HORSHAM DISTRICT COUNCIL CONSULTATION

TO:	Horsham District Council – Planning Dept
LOCATION:	Land To The South of Broadbridge Way Broadbridge Heath West Sussex (Wickhurst green)
DESCRIPTION:	Full Planning Application for the erection of 89no. residential dwellings comprising dwellings (54no.) and apartments (35no.), 36% affordable homes, creation of new vehicular access on to Sergeant Way, provision of public open space, landscaping and drainage solutions
REFERENCE:	DC/25/0894
RECOMMENDATION:	No Objection/Advice
SUMMARY OF COMMENTS & RECOMMENDATION: 3rd set of comments The removal of the cycle route from the rpa's of trees T31 and T19 is welcomed and resolves point 3c below. The remaining points remain to be covered by condition as previously requested. 2nd set of comments Some of the previous concerns and comments have been addressed with thanks. With regards to those comments that haven't been addressed, where appropriate it is recommended that details are secured by condition. However, please note points 3c (avoid encroachment to existing trees rpa's), 5 (land budget) and 30 (surfacing material) are recommended to be addressed prior to determination. Point 13 is also recommend

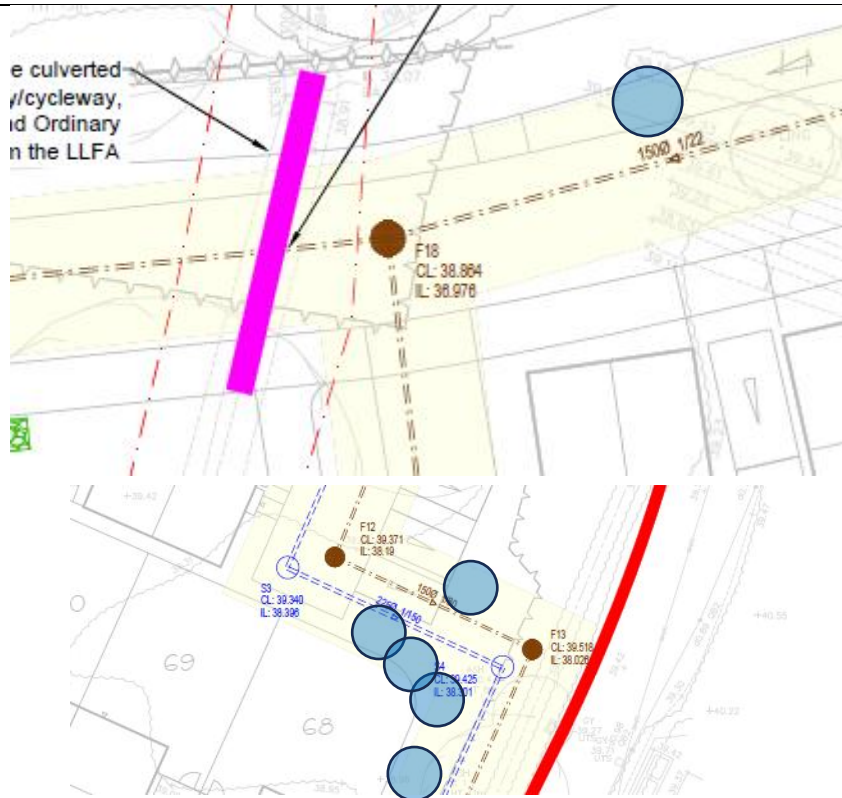
12. The SuDS proposals do not meet the full design criteria listed under 6.7.1 within the FRDR, with Amenity and Biodiversity notably missing from the proposed solutions.

We note from the 'Technical Note Surface Water Drainage: Response to LLFA Comments' that, '*It has not been possible to provide SuDS across the site in order to intercept the first 5mm of rainfall for the majority of rainfall events due to development specific constraints*'. We do not concur with this statement and consider that there are further opportunities for SuDS that can be delivered on site, that also address the unmet design criteria of Amenity and Biodiversity. For example:

- a. Rain gardens, as noted under point 6
- b. Introducing blue green roofs to ancillary structures such as bin and cycle stores, which would be highly effective given their combined water collection area
- c. Wetland planting within the Open Space and/or alongside the stream and riparian buffer

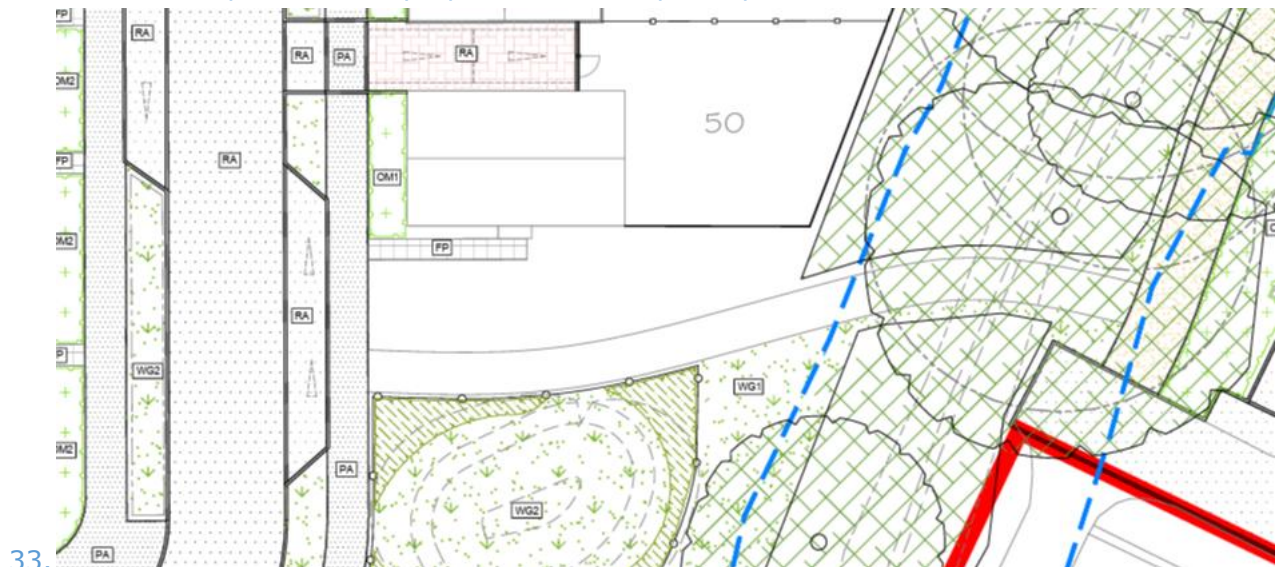
27. Please update the Boundary Treatments Plan (BTP) to reflect 'Landscaping buffer – hedges' as indicated in the key. [This has been added to the plans with thanks but are all the proposed hedges, including those in the front gardens to be 1.8m in height? This is not considered appropriate.](#)
28. Please provide specification for the brick boundary walls, noting that some level of brick detailing would be recommended for visual amenity and interest. [Not addressed, please secure by condition](#)
29. Post and rail fence should be added to the BTP for gardens alongside the central ditch, however this is not necessary if the layout is adjusted as per point 3. [Closed](#)
